MAHONING ROAD NE
 STA-0153-01.70

REVISIONS:
 CONSTRUCTION BIDDING SET
 APPENDIX NO. 1

REVISIONS	DATE	BY
CONSTRUCTION BIDDING SET	4/21/14	GEA
ADDENDUM NO. 1	5/7/14	GEA

STREETSCAPE PLAN
STA. 78+00 TO STA. 89+50

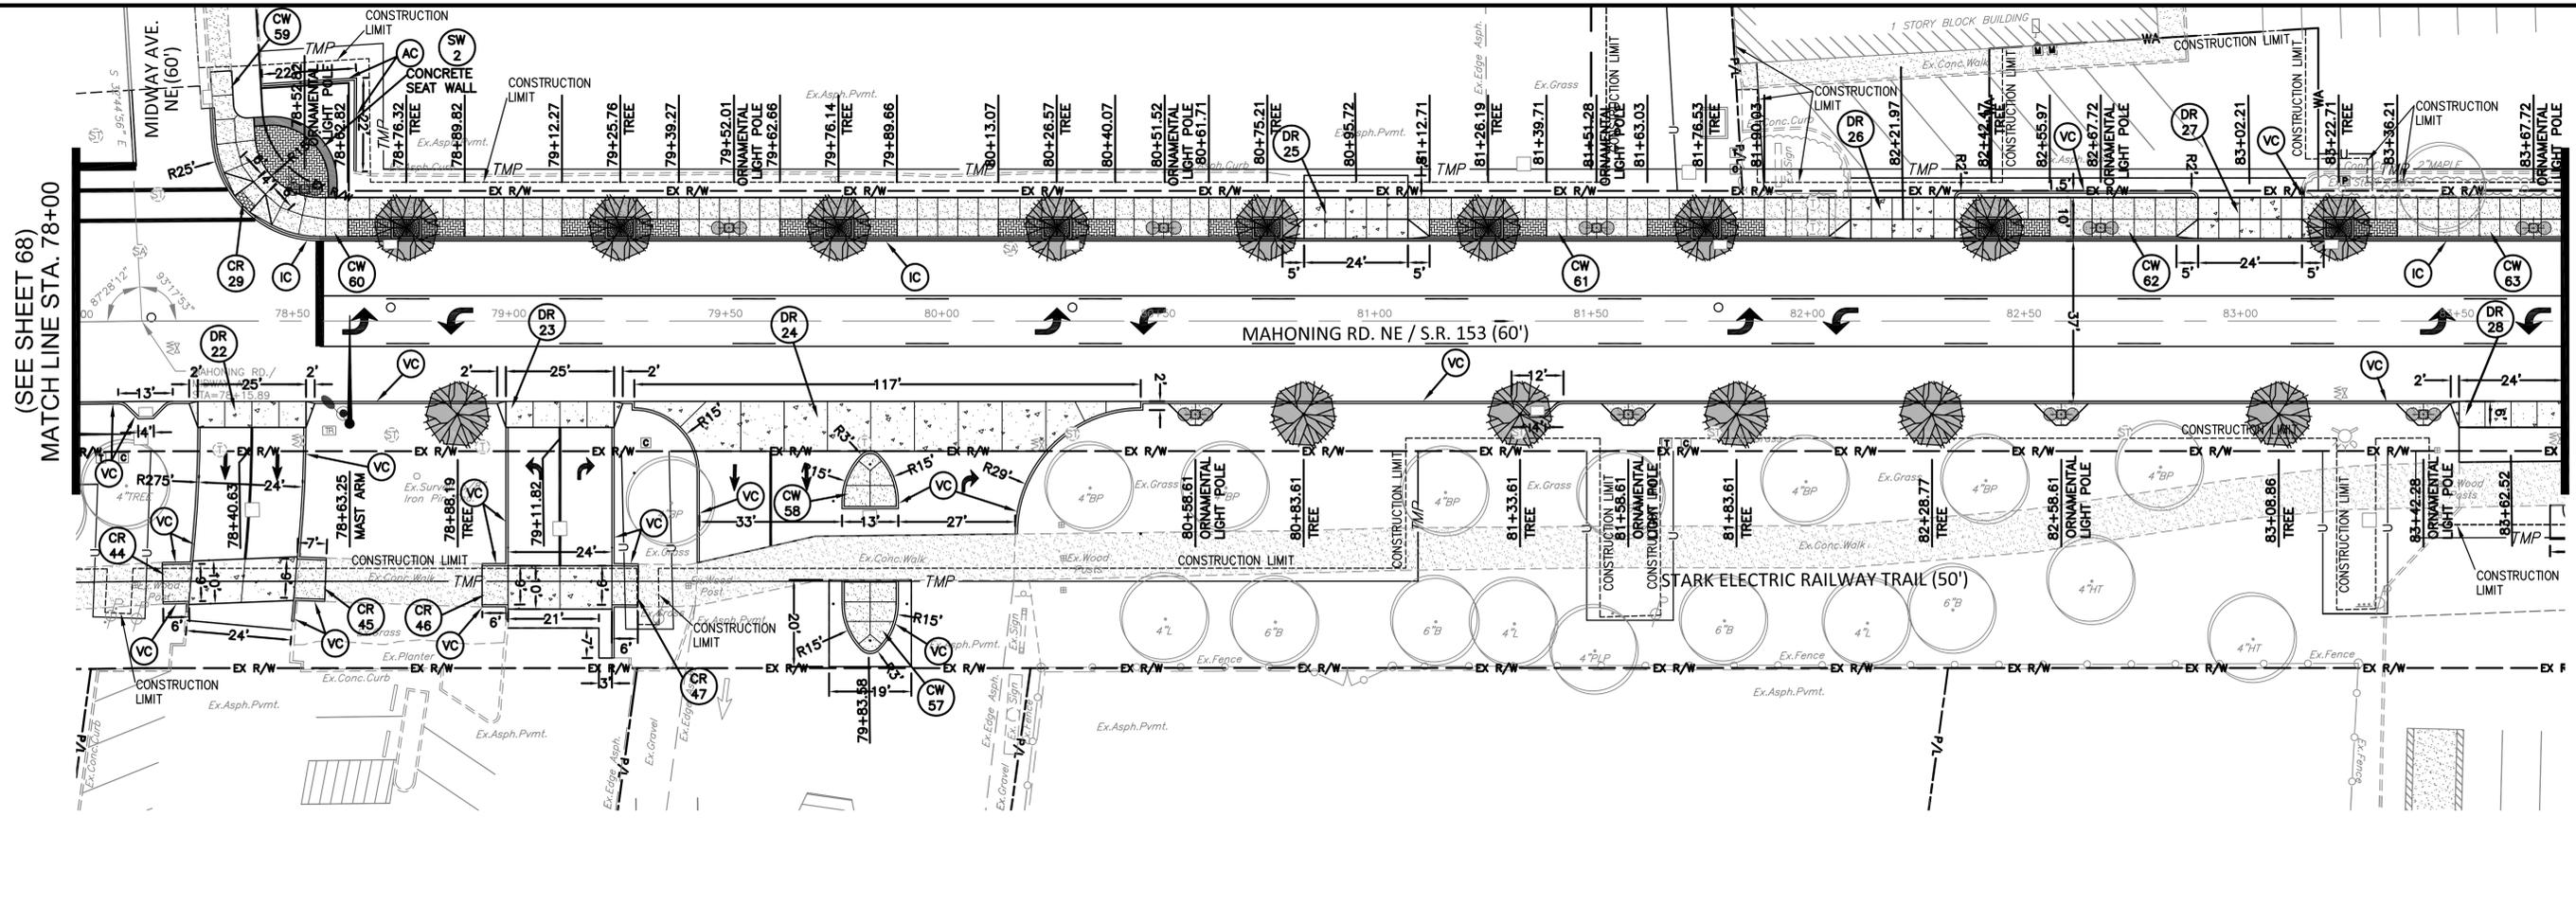
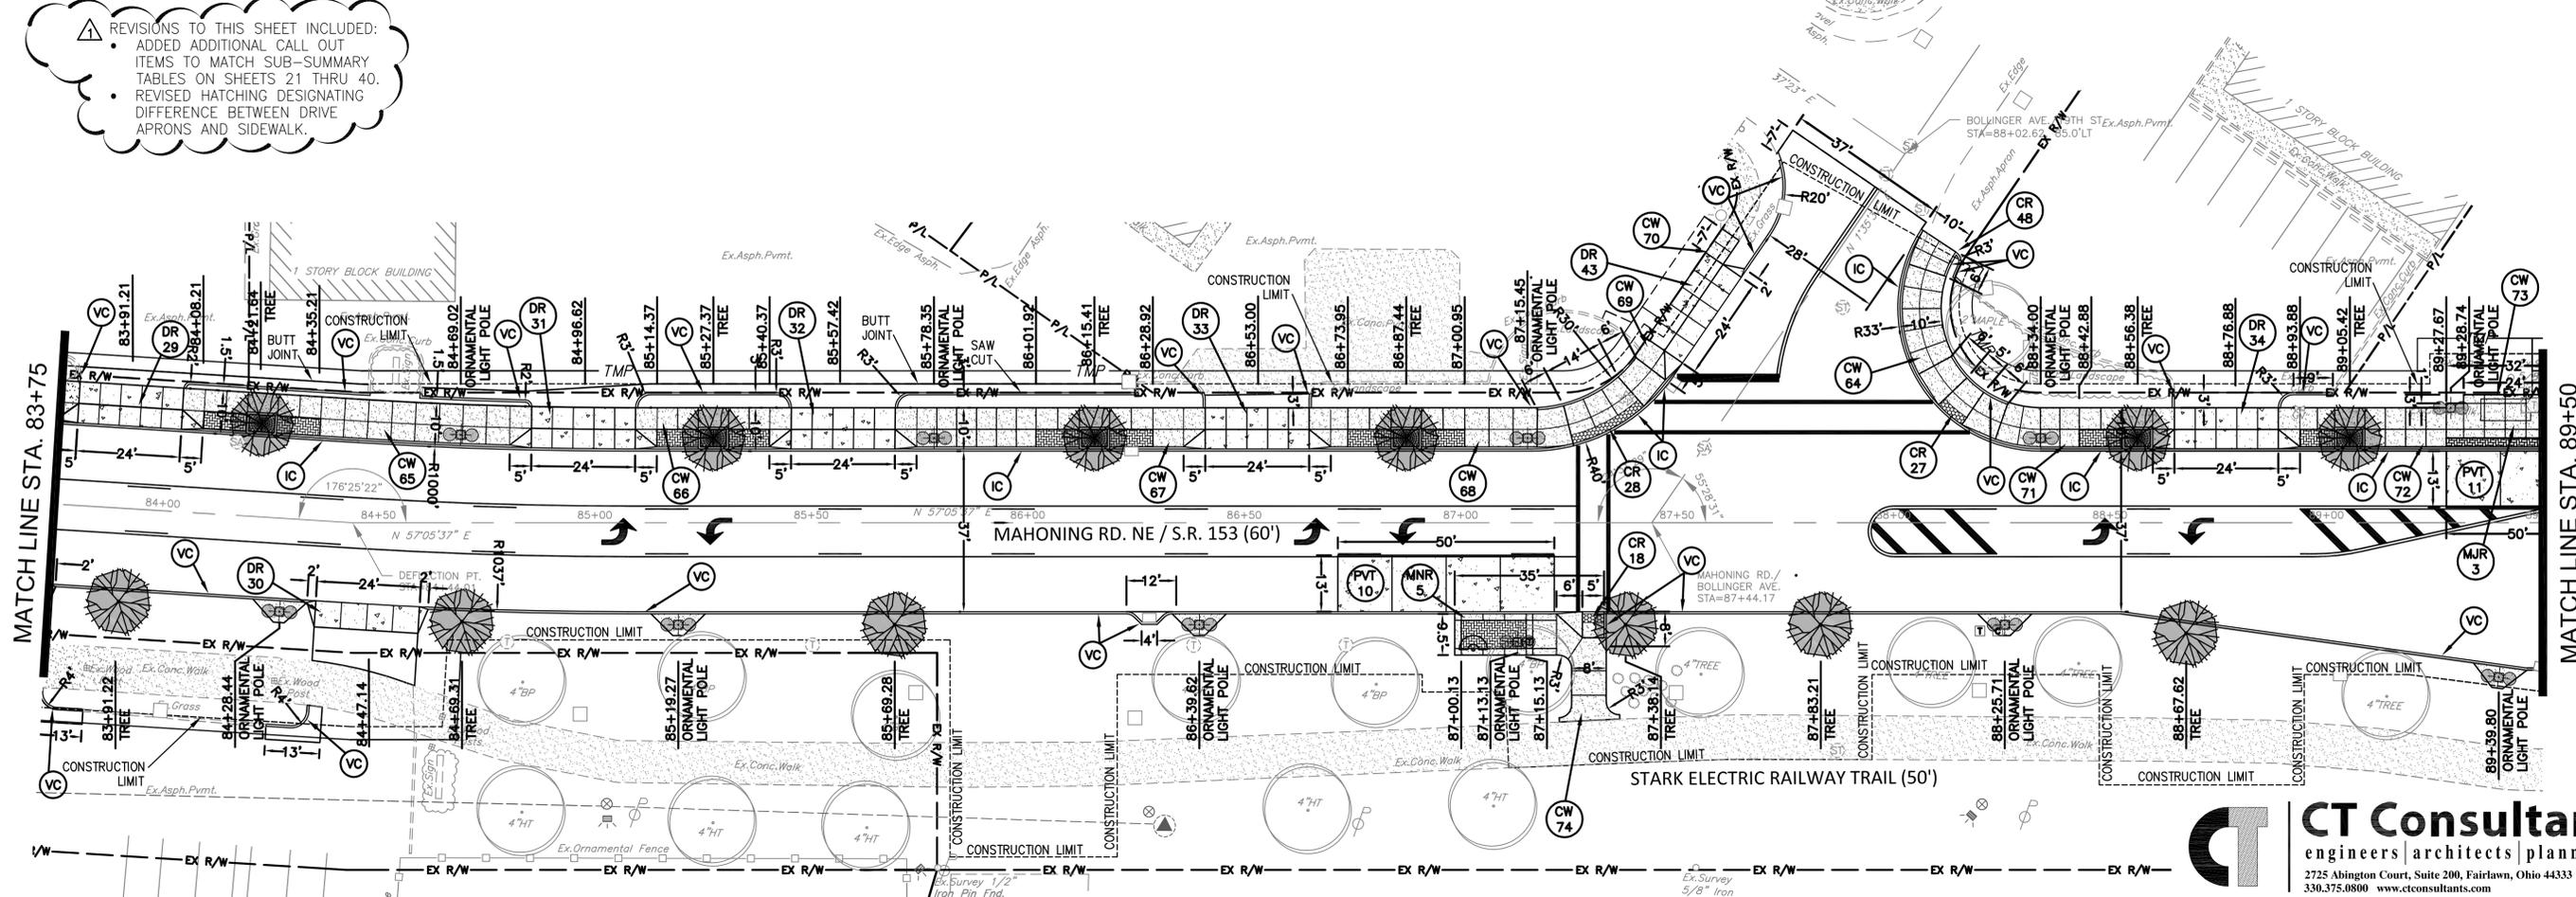
REVISIONS TO THIS SHEET INCLUDED:

- ADDED ADDITIONAL CALL OUT ITEMS TO MATCH SUB-SUMMARY TABLES ON SHEETS 21 THRU 40.
- REVISED HATCHING DESIGNATING DIFFERENCE BETWEEN DRIVE APRONS AND SIDEWALK.

STREETSCAPE PLAN
STA. 89+50 TO STA. 95+50

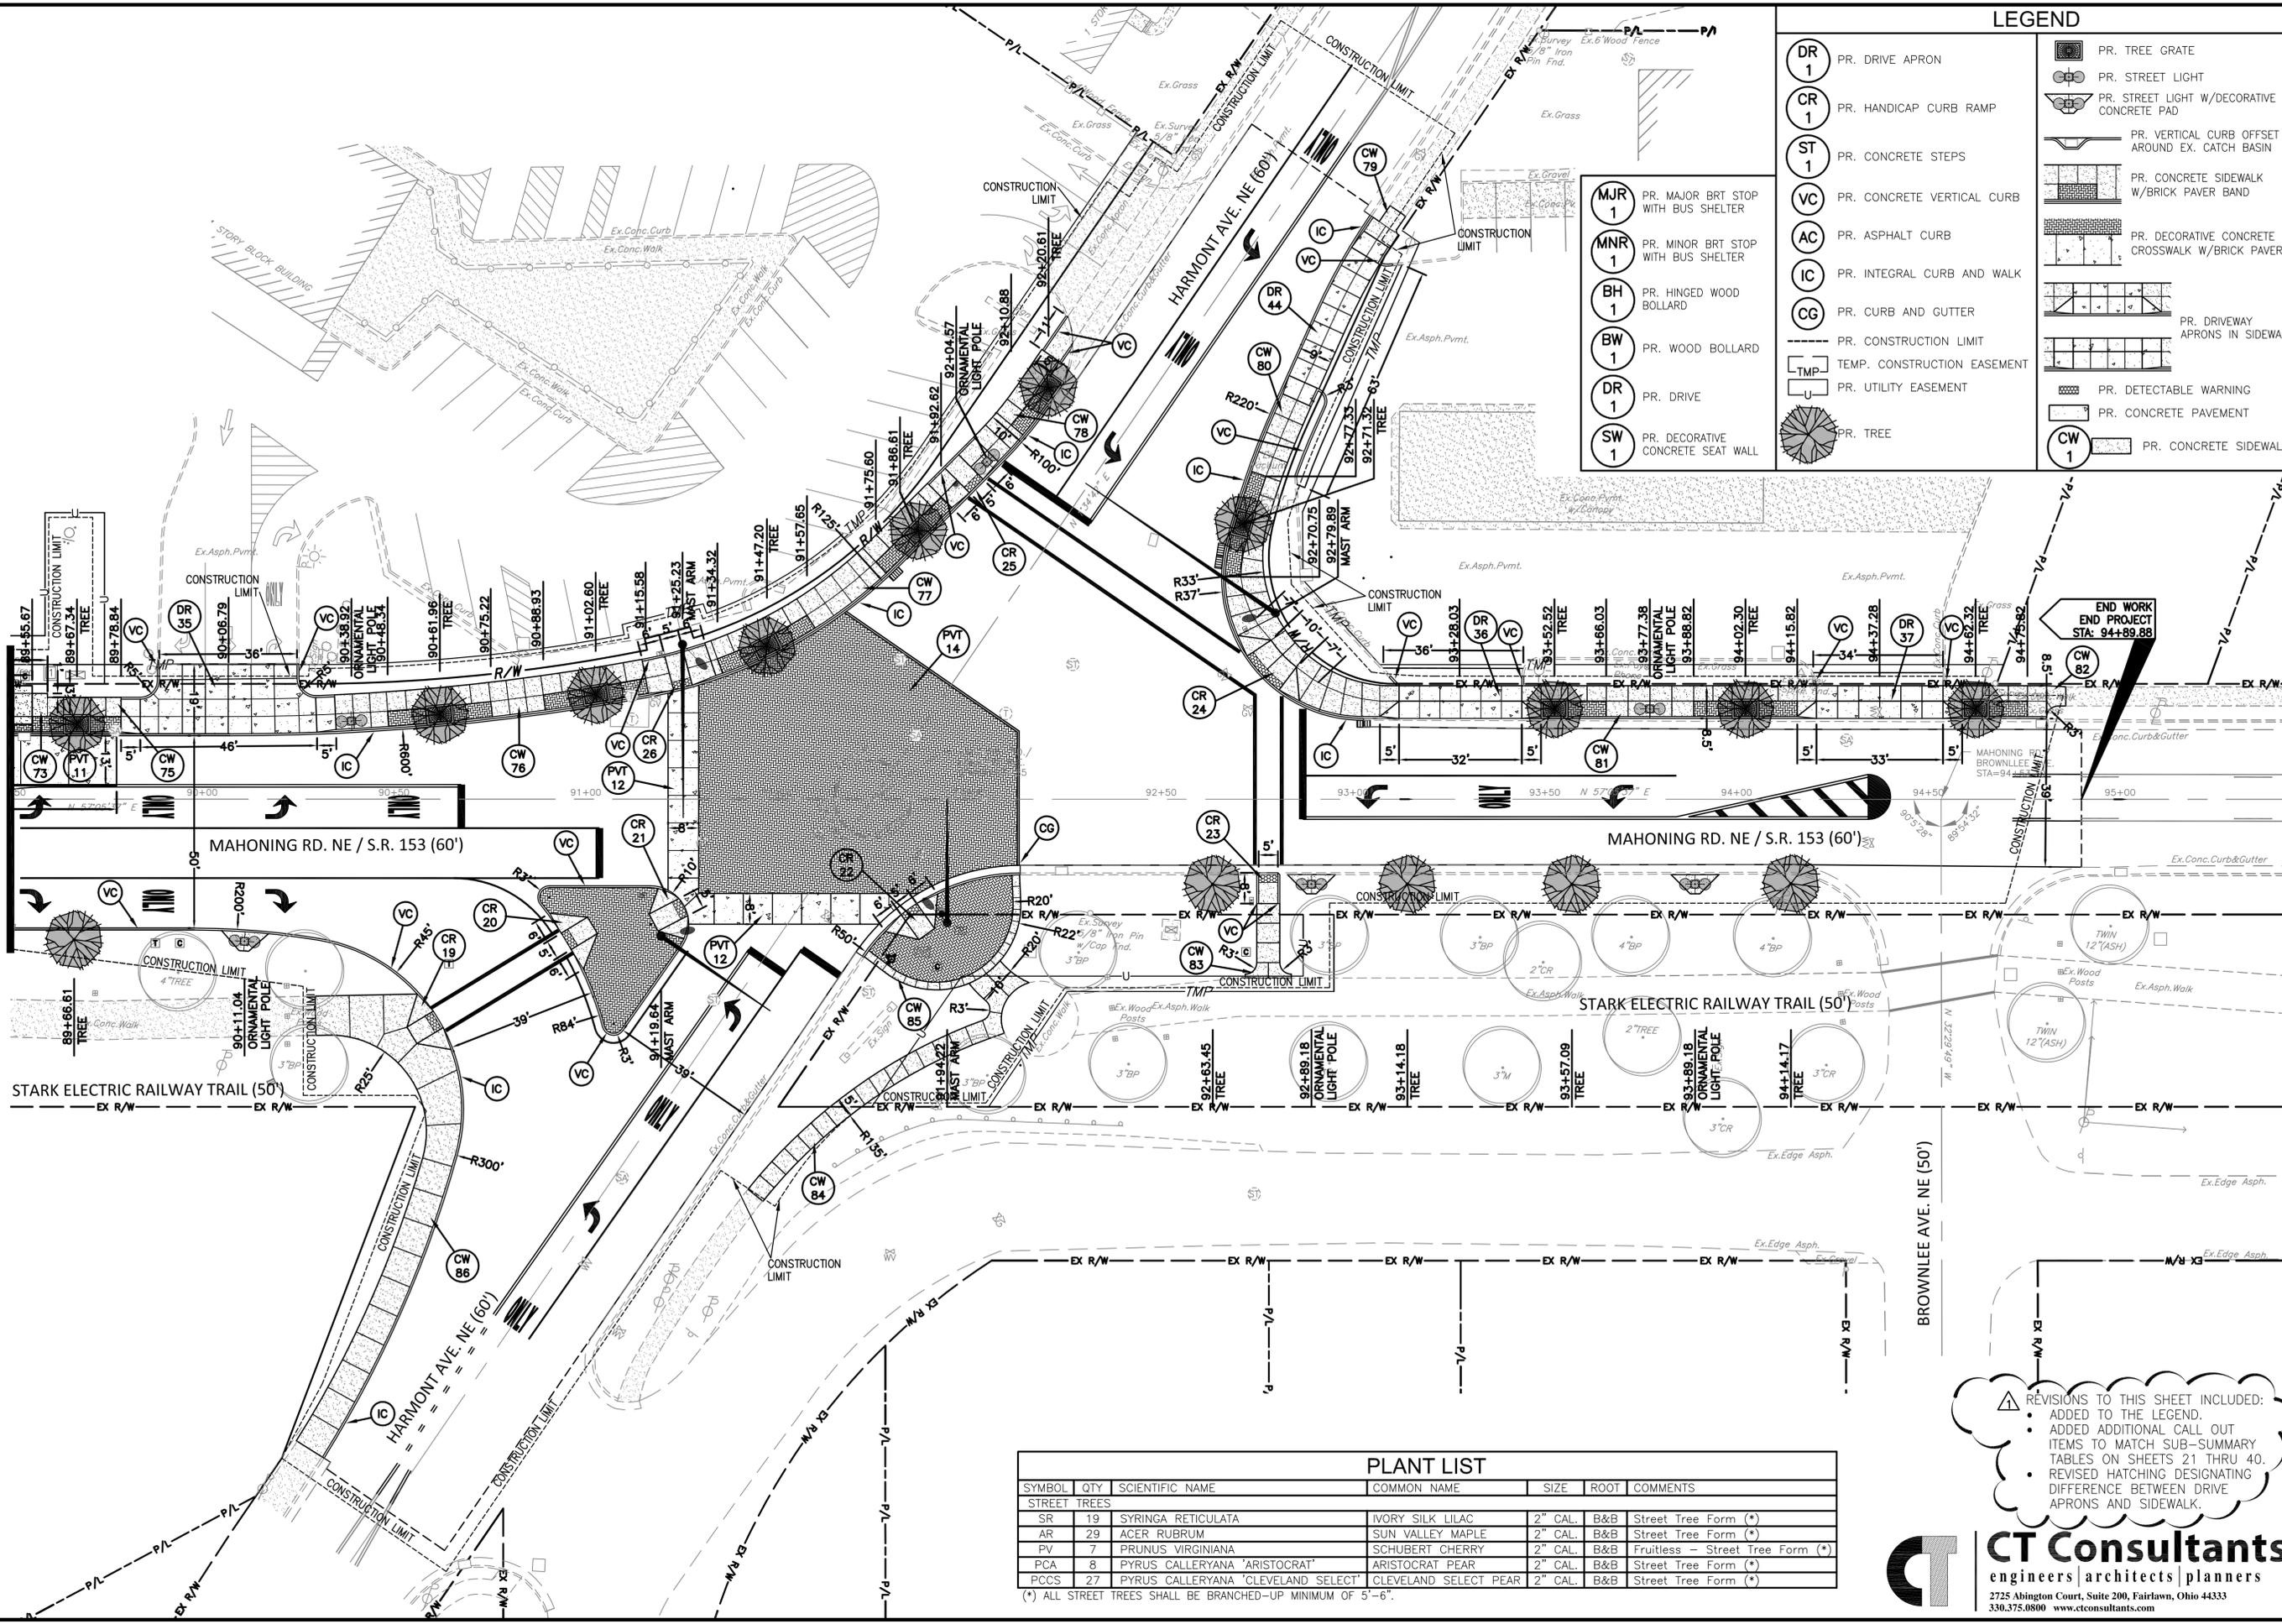
REVISIONS TO THIS SHEET INCLUDED:
 • ADDED TO THE LEGEND.
 • ADDED ADDITIONAL CALL OUT ITEMS TO MATCH SUB-SUMMARY TABLES ON SHEETS 21 THRU 40.
 • REVISED HATCHING DESIGNATING DIFFERENCE BETWEEN DRIVE APRONS AND SIDEWALK.
